**SONY**  
Broadcast

maintenance and modification information for the one-inch line of Sony Broadcast Products

model: BVH-1000A / BVH-1100A

bulletin no.: 11

Figure 1

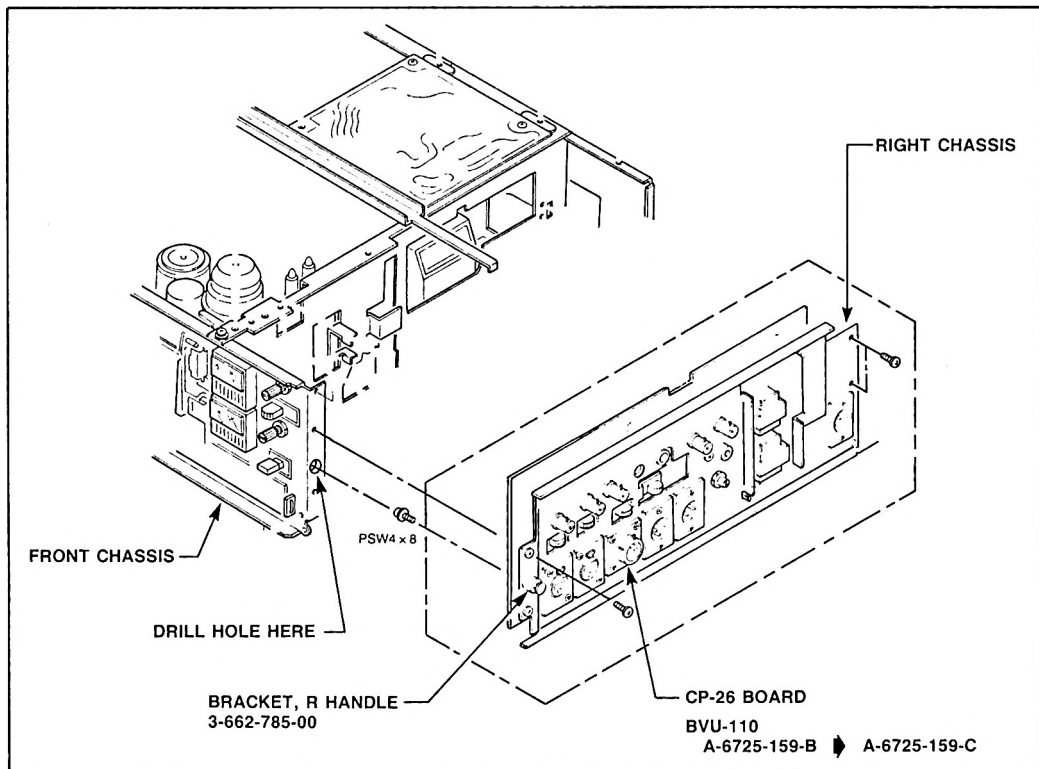
The CP-26 Board, R Handle Bracket and the method for attaching the bracket have been changed in units with S.N. 20,651 and higher. (See Figure 1.) Installation of the new board in units with S.N. preceding 20,651 will require drilling a hole in the Front Chassis as illustrated below. Table 1 indicates the interchangeability of former and new parts.

Figure 1

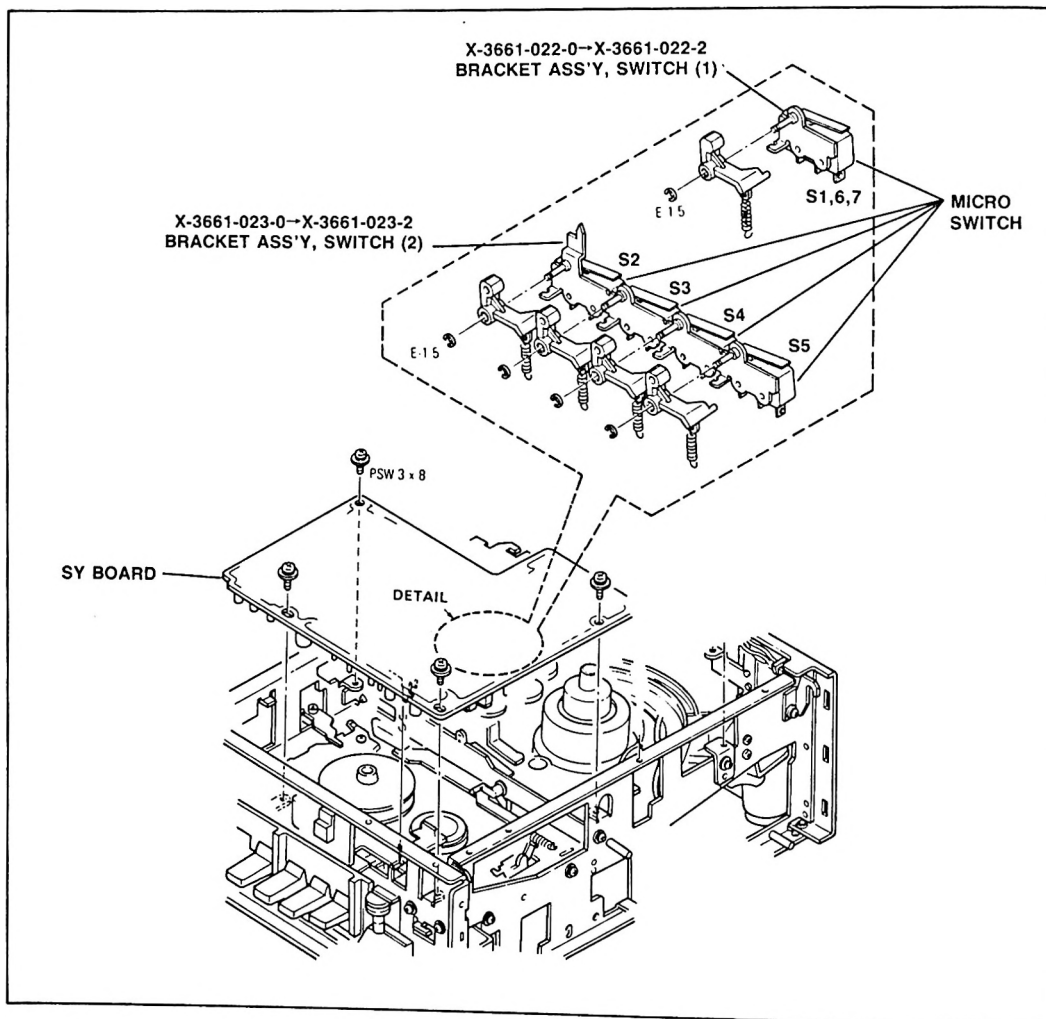
1. Replace former switch bracket assembly with new part as shown in Figure 1, then install new switches to new assembly. Or . . .
2. Modify former switch bracket assembly by cutting off section "A," then install new switches parallel to former assembly as shown in Figure 2.

**Figure 1**

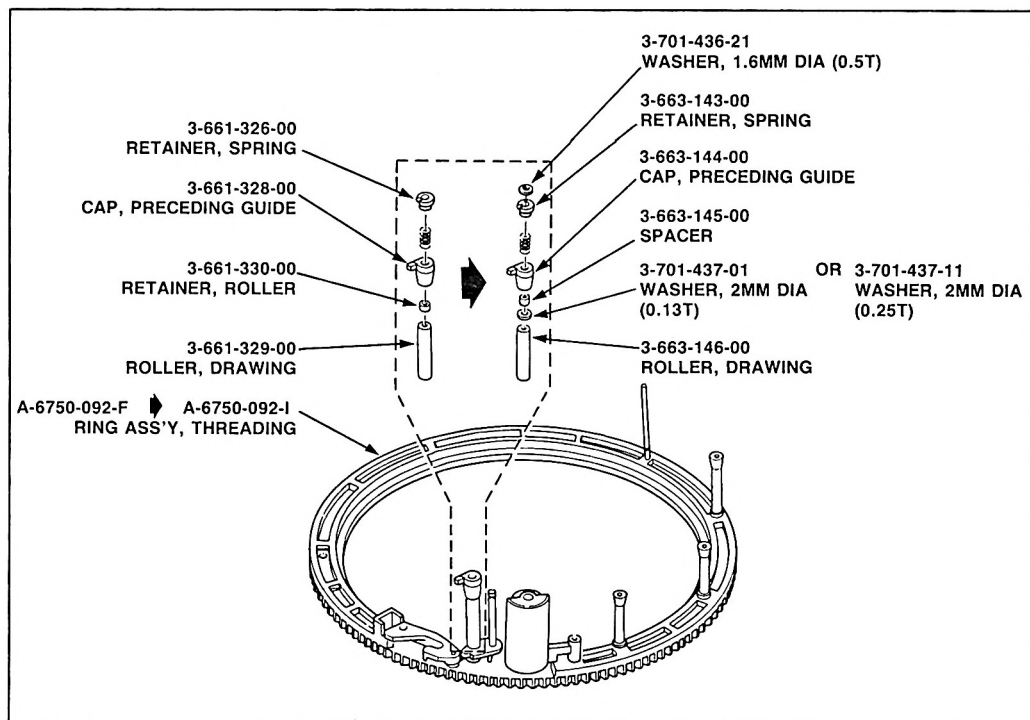
The Drawing Roller has been changed to make part replacement easier. (See Figure 1.)

- NOTE:** 1. Check that the thrust clearance of the Drawing Roller meets the required specification of 0.2 - 0.3mm.  
2. Adjust the clearance by adding or removing washer (2mm dia) P.N. 3-701-437(-01/-11).

Figure 1

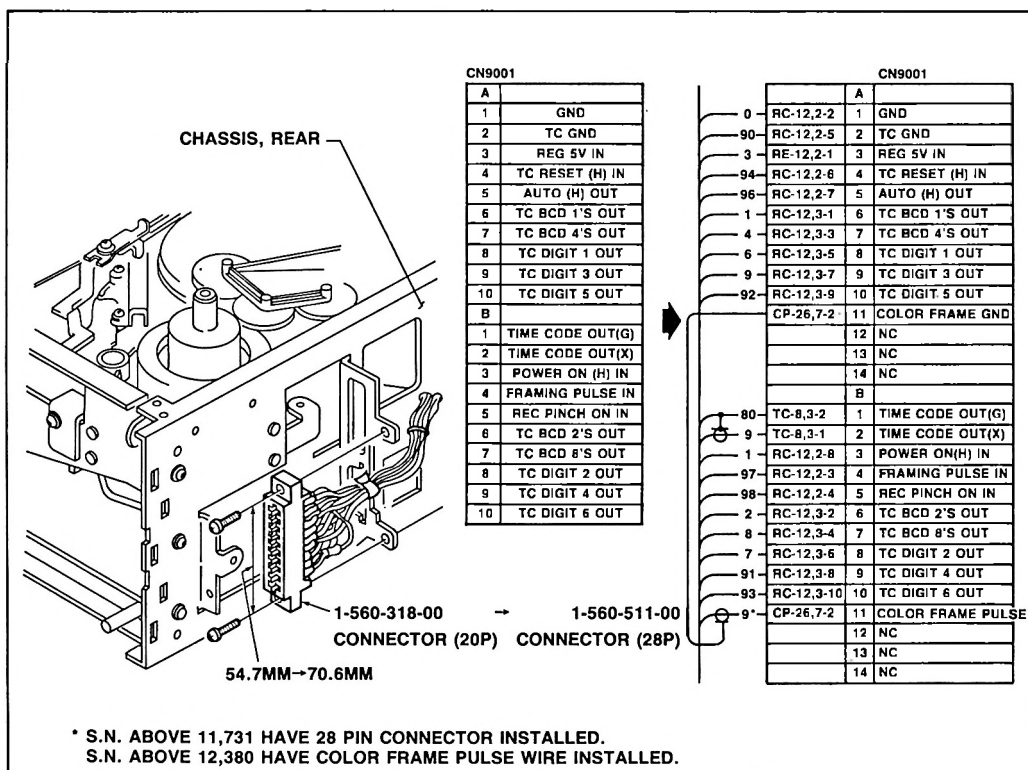
The 20P connector (1-560-318-00) for the BK-111 TIME CODE on the BVU-110 has been changed to 28P connector (1-560-511-00) to make it compatible with other BVU-110 series. (See Figure 1.) To update earlier machines, the following items listed in Table 1 are required. The BK-111 or BK-112 can then be used in both early and later units.

Figure 2

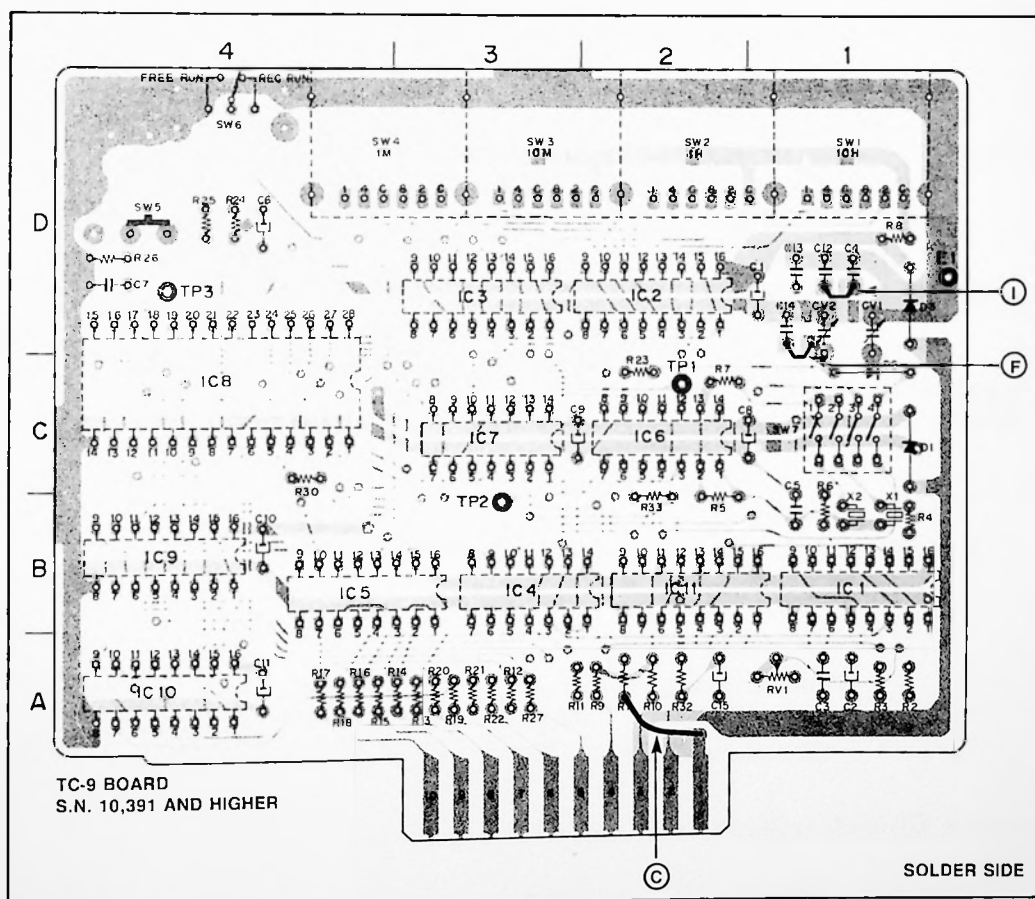
- (i) Set SW7-1, SW7-4 to OFF position.  
Set SW7-2, SW7-3 to ON position.
- (ii) Connect frequency counter to TP1.
- (iii) For units with serial numbers up to 10,390, C4 is connected as shown (G) in Figure 1).
- (iv) Adjust CV1 to obtain a counter reading of  $38.4 \text{ kHz} \pm 0.4 \text{ Hz}$ .
- (v) If the specified reading is not obtained, readjust CV1 after performing one of the following steps.
  - For units with serial numbers up to 10,390, solder bridge between the points designated (H) in Figure 1.
  - For units with serial numbers 10,391 and higher, solder bridge between the points designated (I) in Figure 2.

**Figure 1. ARM ASS'Y, TR**

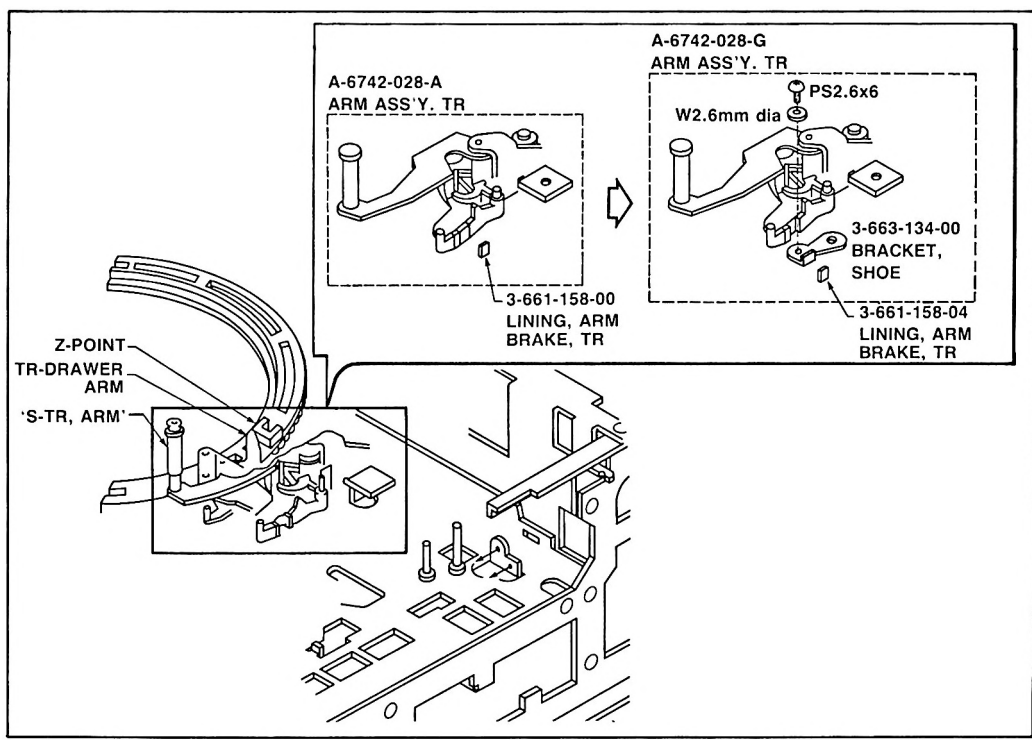
The threading arm assembly ('ARM ASS'Y, TR') has been changed in units with serial numbers 10,811 and higher to allow adjustment for optimal contact between 'TR-DRAWER ARM' and the 'Z-point' of the threading ring. (See Figure 1.) Specifically, this change is to draw out the thread supply arm ('S-TR, ARM') more securely at the threading-end. Perform adjustments on page 3 after the modification is complete.

Figure 1

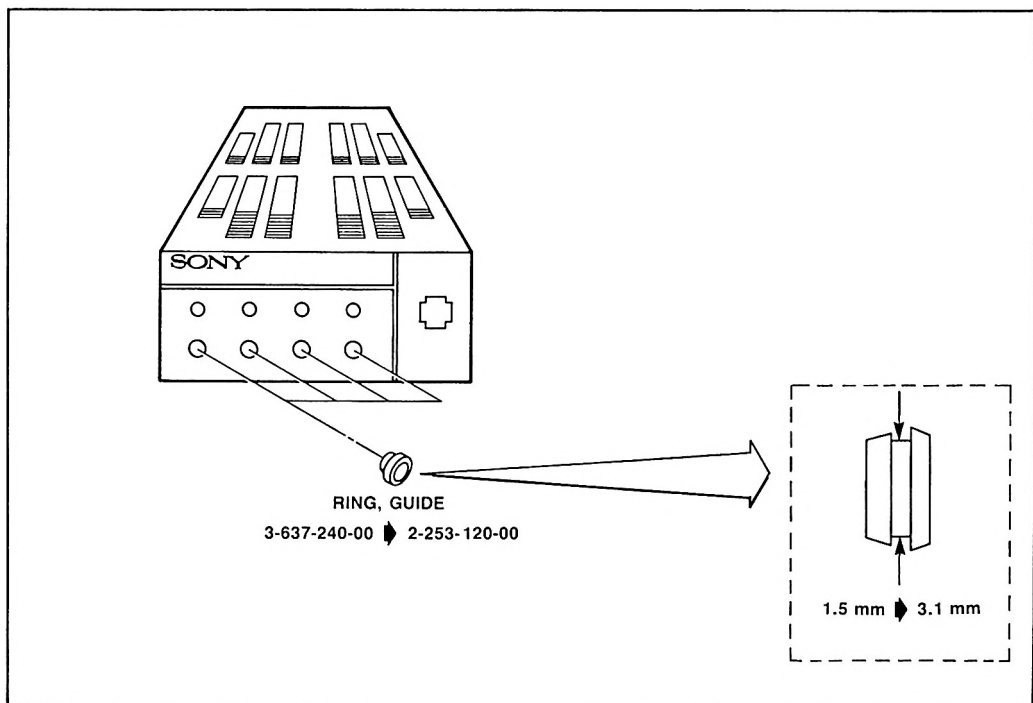
The battery connector guide ring has been changed in units with serial numbers 10,981 and higher. The new guide ring attaches more securely to the connector, eliminating the tendency for the part to come loose. The new part can be installed in units with serial numbers below 10,981.

Figure 1

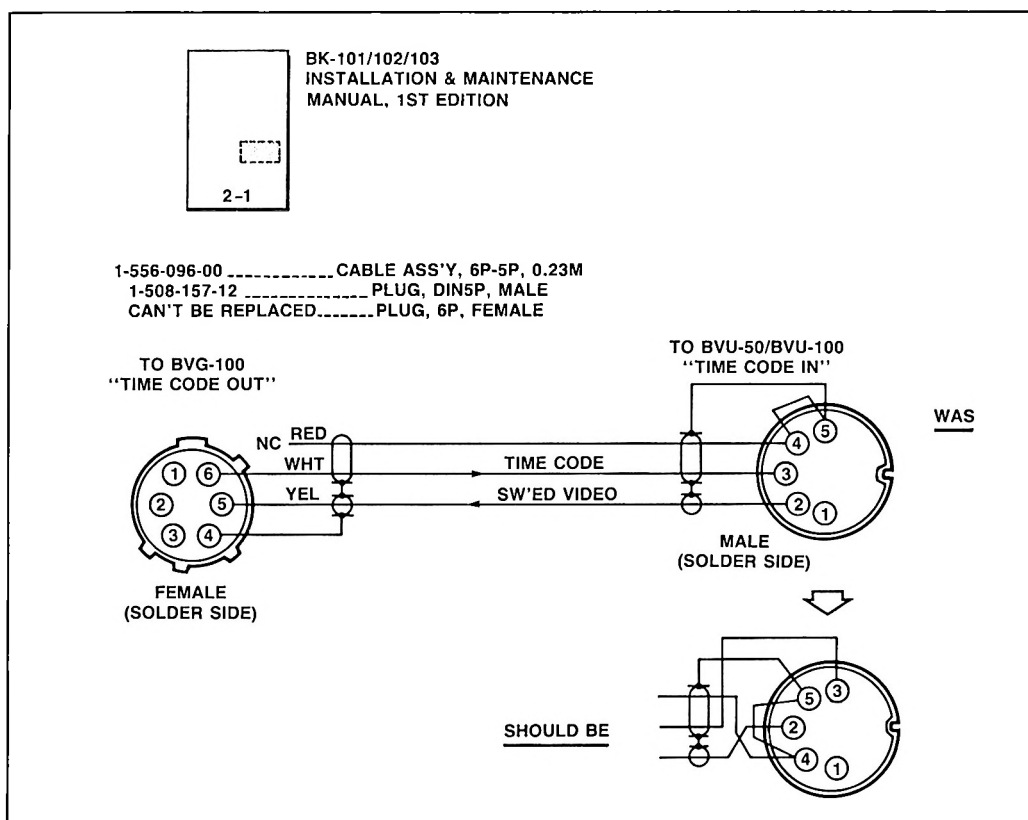
In the BK-101/102/103 Manual (1st Edition), pin assignments for the 6P-5P cable used in the BK-102 and 103 are in error. Please correct your manual as shown in Figure 1.

Figure 1

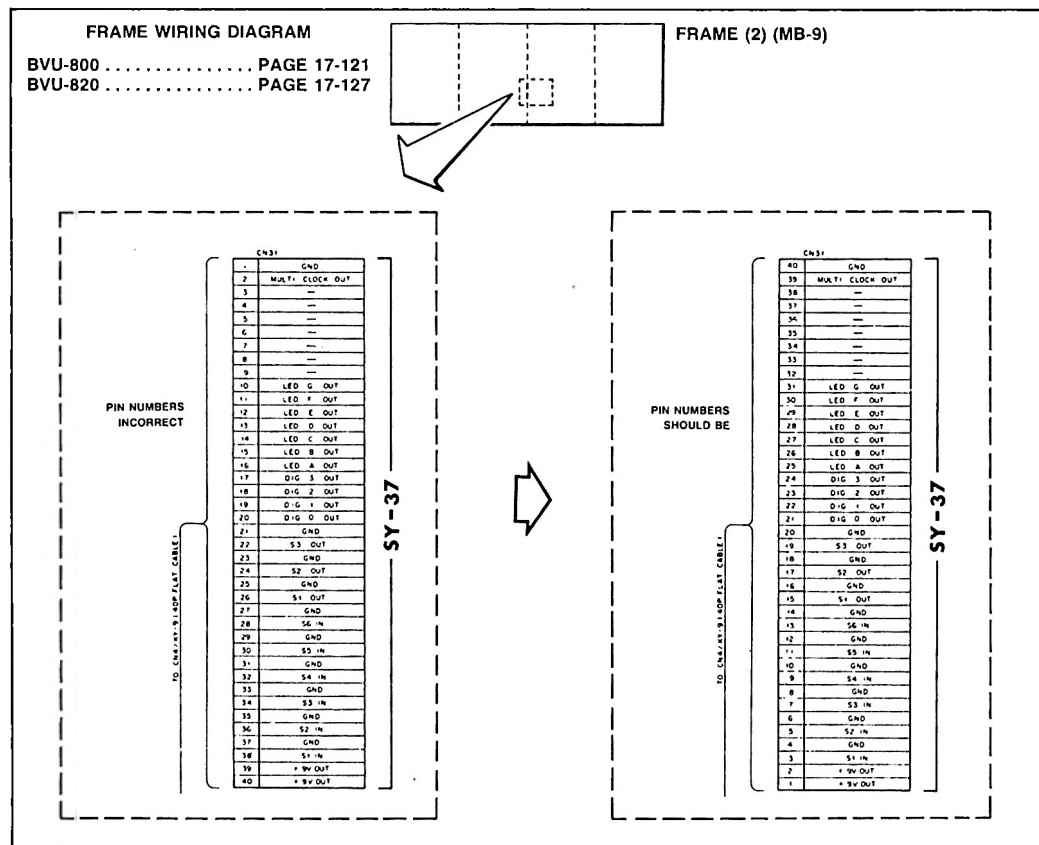
Please make the following corrections (Figure 1) to the Frame Wiring Diagram in the BVU-800/820 Operation and Maintenance Manual, all editions.

**Figure 1**

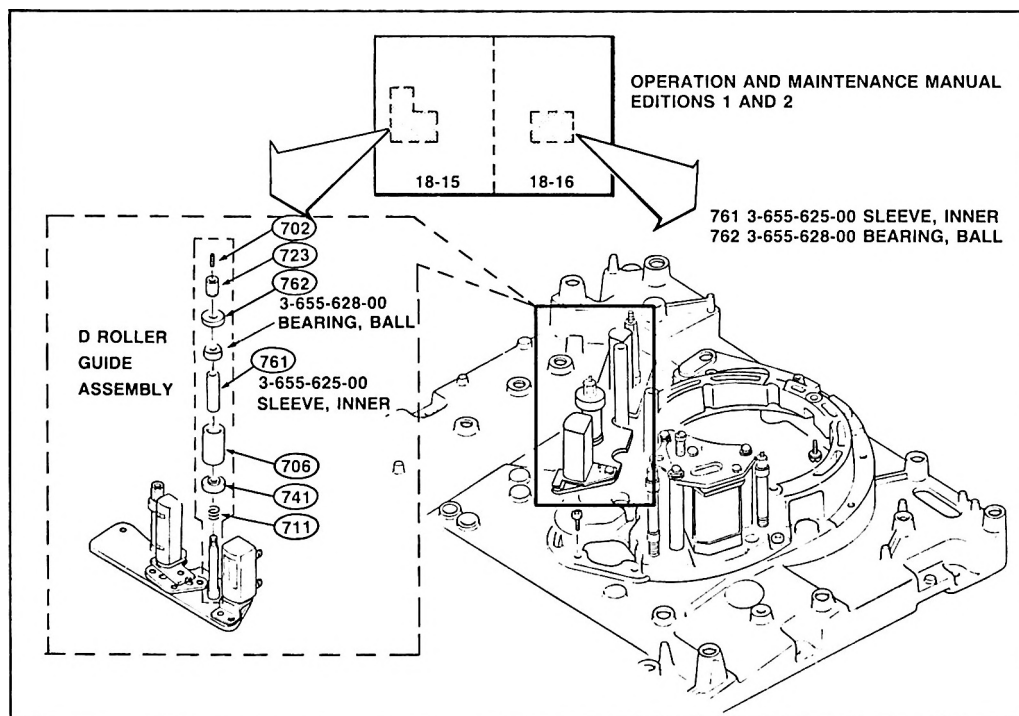
For production reasons the "Sleeve, Inner" (3-655-625-00) and "Bearing, Ball" (3-655-628-00) have been added to the D Roller Guide Assembly. (See Figure 1.) Please add the new part numbers to your service manual, 1st and 2nd Edition as shown in Figure 1. (All machines already have these parts.)
